## Annex X

### Test Specifications for Automated Lane Keeping Systems (ALKS)

5.5.1. Cut-In Tests

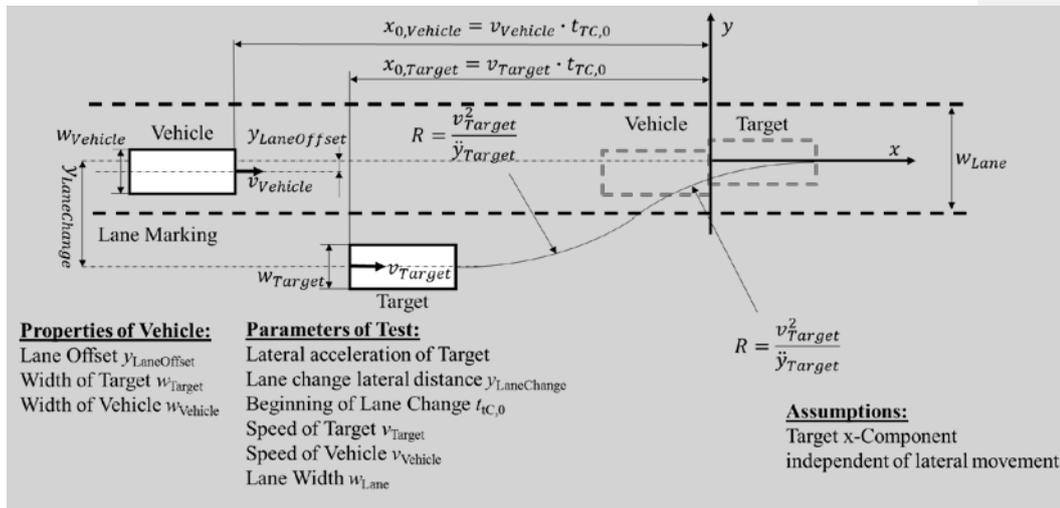
**Kommentiert [N17]:** This scenario is covered by the traffic disturbance scenario discussed in the VMADSG1a so seems not necessary.

5.5.2. Cut-Out Tests

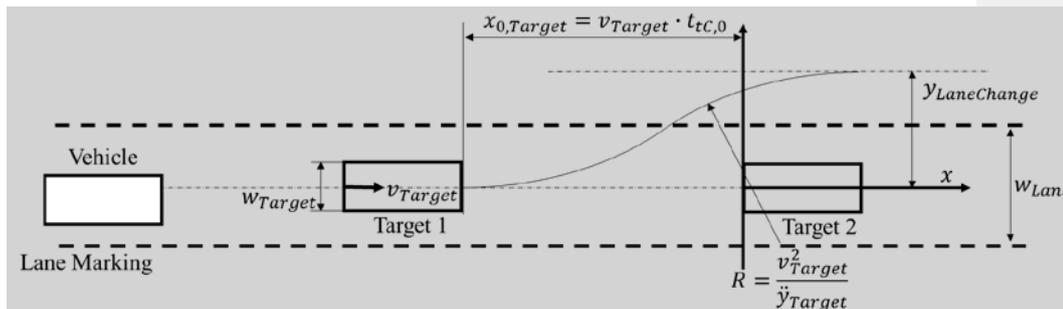
**Kommentiert [N18]:** This scenario is covered by the traffic disturbance scenario discussed in the VMADSG1a so seems not necessary in this Annex. Necessity of this requirement should be discussed in the SG1a.
